# PERMIT

## ON-SITE SEWAGE DISPOSAL SYSTEM HOWARD COUNTY HEALTH DEPARTMENT BUREAU OF ENVIRONMENTAL HEALTH

SUBDIVISION: Glenelg Manor LOT NUMBER: 10 C

ADDRESS: 12757 Folly Quarter Road PROPERTY OWNER: Judith Meyers

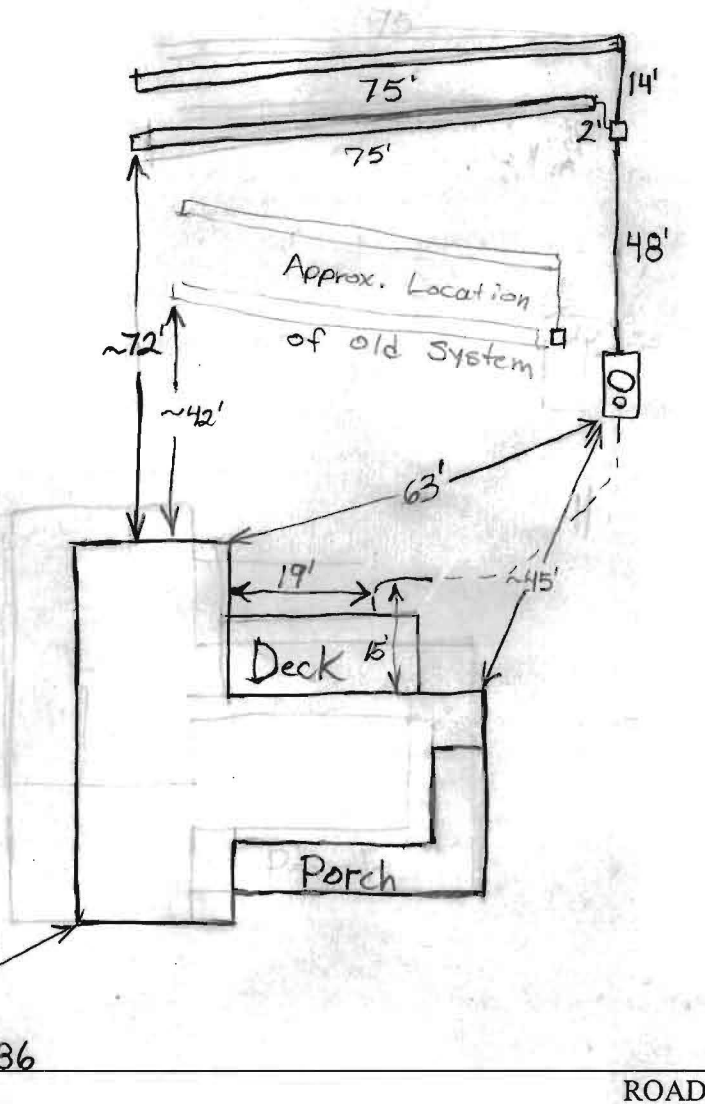
PRE-CONSTRUCTION 11/17/03 Tank set. No one on site. At least one trench is failing per Trogles. Will need repair. (BB)

INSTALLATION 11/21/03 Old tank pump and filled with stone per Trogles. Old trenches and distribution box left intact. O.K. to cover everything. (BB)

PROPOSED PLAN FOR POOL LOC. W/S.T. RELOCATION

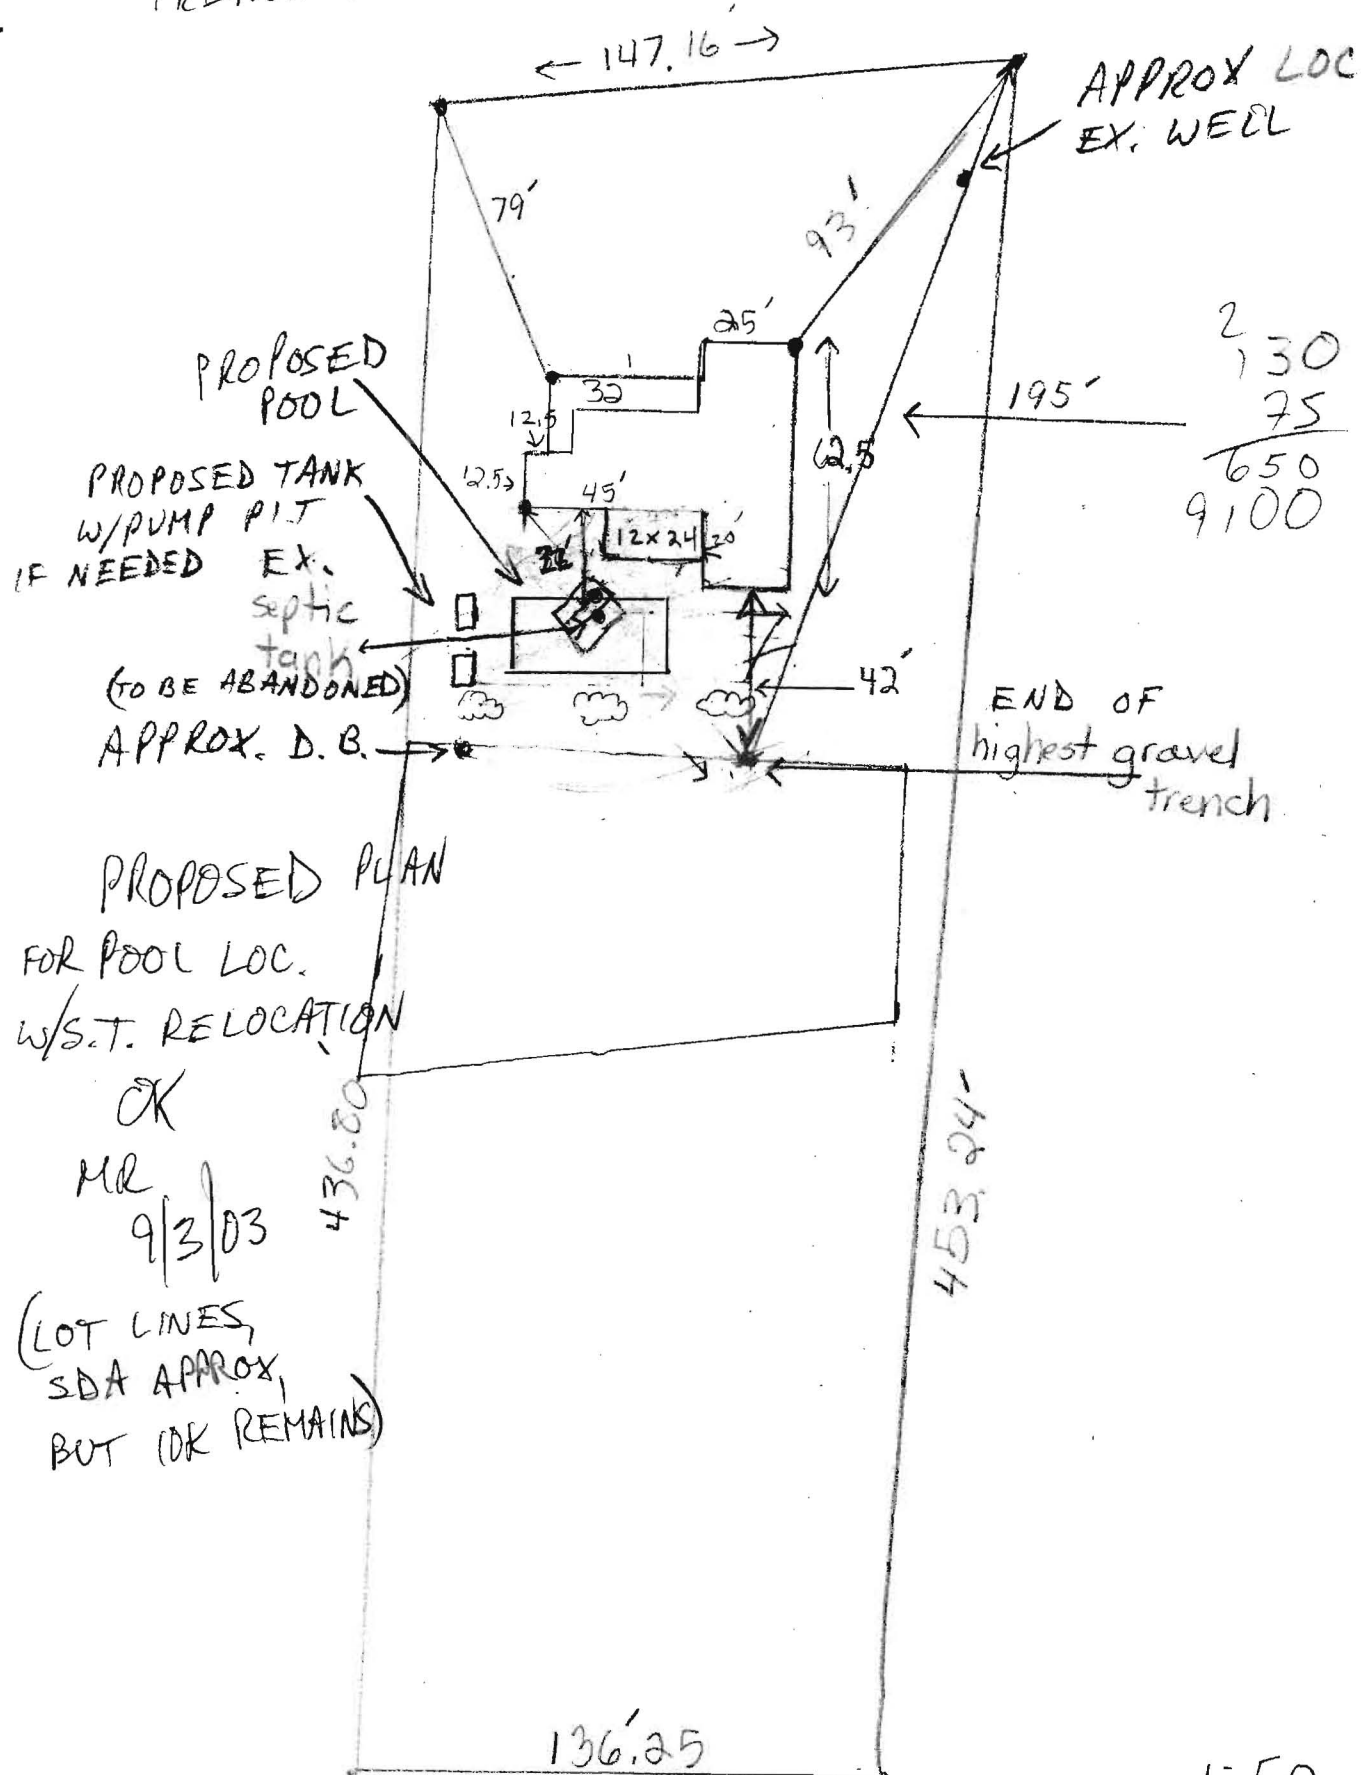
03 w/OWNER: 10K APPARENTLY REMAINS DOWNHILL OF HIGH TRENCH AS SHOWN

(LOT LINES, SDA APPROX, BUT OK REMAINS)

OK MR 9/3/03
